RESOLUTION NO. 2207

A RESOLUTION OF THE CITY COUNCIL OF THE CITY OF KIRKLAND AMENDING SECTION 3 OF RESOLUTION NO. 2202 WHICH APPROVED THE PRELIMINARY APPLICATION OF A PLANNED UNIT DEVELOPMENT TO BE KNOWN AS YARROW BAY OFFICE COMPLEX BEING DEPARTMENT OF COMMUNITY DEVELOPMENT FILE NO. PUD-73-32(H) AND PROVIDING THAT CONSTRUCTION OF AN AUTOMOBILE AND PEDESTRIAN BRIDGE ACROSS THE REALIGNMENT OF YARROW CREEK SHALL BE WITHIN THE AUTHORIZED SITE PREPARATION WORK AND CREEK BED REALIGNMENT.

AMENDED
ADMINISTRATIVE REPORT

TRANSMITTAL REPORT
LAKE VISTA TERRACE DIV. NO. 2

LAKE VISTA TERRACE DIVISION NO. 2

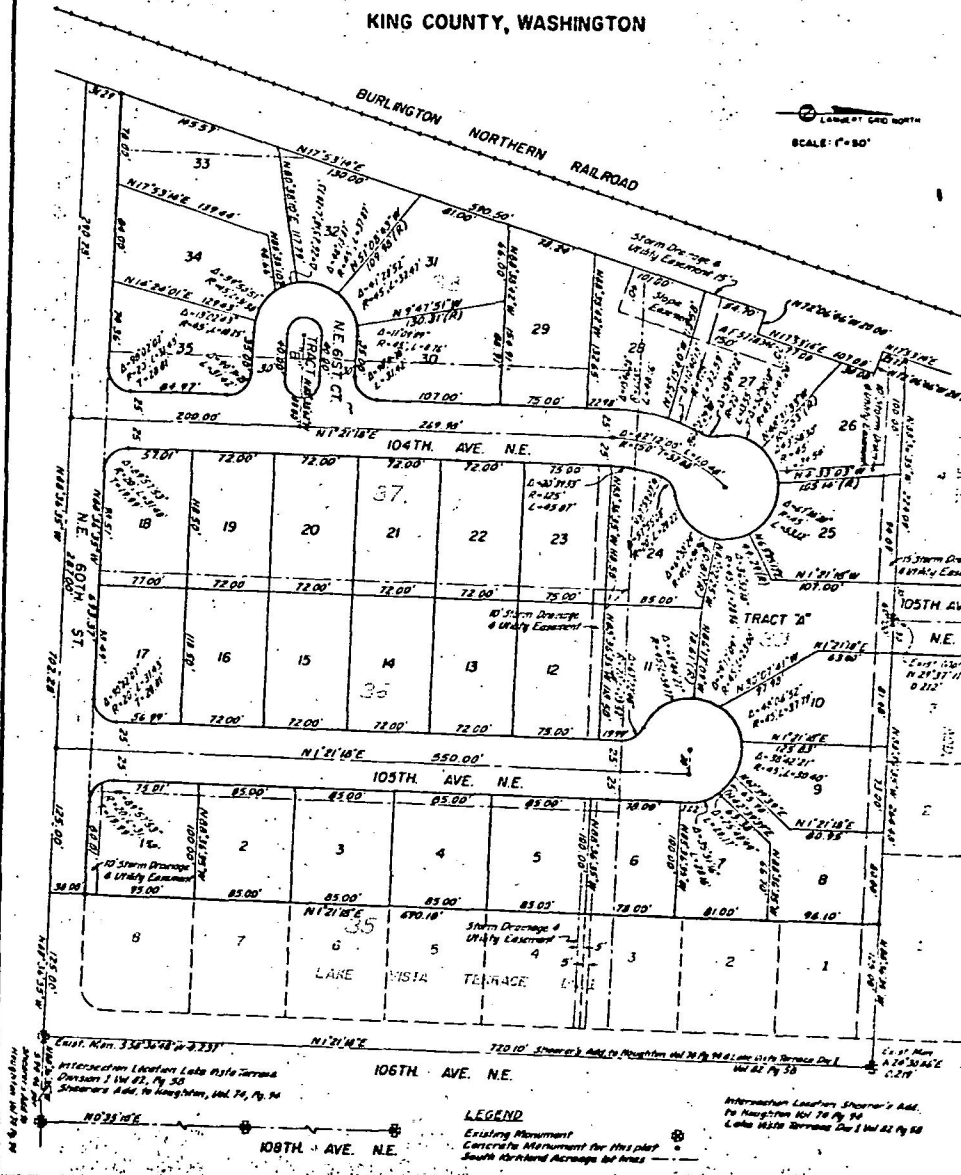
3. A storm drainage holding basin not be required between Lots 27 and 29.
4. That the 3.58 open space be required to be located between Lots 10, 11, 24 and 25 and the following improvements to be made:

- a. A 10 foot paved walkway is to be constructed connecting 105th Ave. N.E. to the north with 104th Ave. and 106th Ave. to the south.
 - b. A 3'6" cedar fence, as submitted by the applicant to the City, is to be installed adjacent to Lots 10, 11, 24 and 25.

- c. The area is to be graded and seeded.
 - d. That this open space, referred to as Tract A, be deeded to the City of Kirkland with costs of future improvements and/or maintenance to be borne by all lot owners within the plat.

5. Tract B, the island in the small cul-de-sac on 104th Ave. N.E., is to be deeded to the City with the costs of future improvements and/or maintenance to be borne by the owners of Lots 30, 31, 32, 33, 34 and 35.

6. That a variance be granted to allow a 20 foot frontage for access to Lots 8 and 33

1. The Houghton Community Council and Planning Commission hereby adopt the above conditions and recommend approval of the Final Plat of Lake Vista Terrace Division No. 2 subject further to the following conditions.
 - a. That a barricade be installed along the entire northern portion of Tract A to the satisfaction of the Park Director which would allow only pedestrians to pass through, and not cars or motorcycles.
 - b. That prior to the filing of the Final Plat, a bond shall be deposited with the City of Kirkland to cover the cost of all public improvements not completed, and the bond size to be determined by the Public Service Director.
2. A copy of the revised Final Plat drawings are hereby attached to this report and approved subject to the conditions and stipulations contained herein.
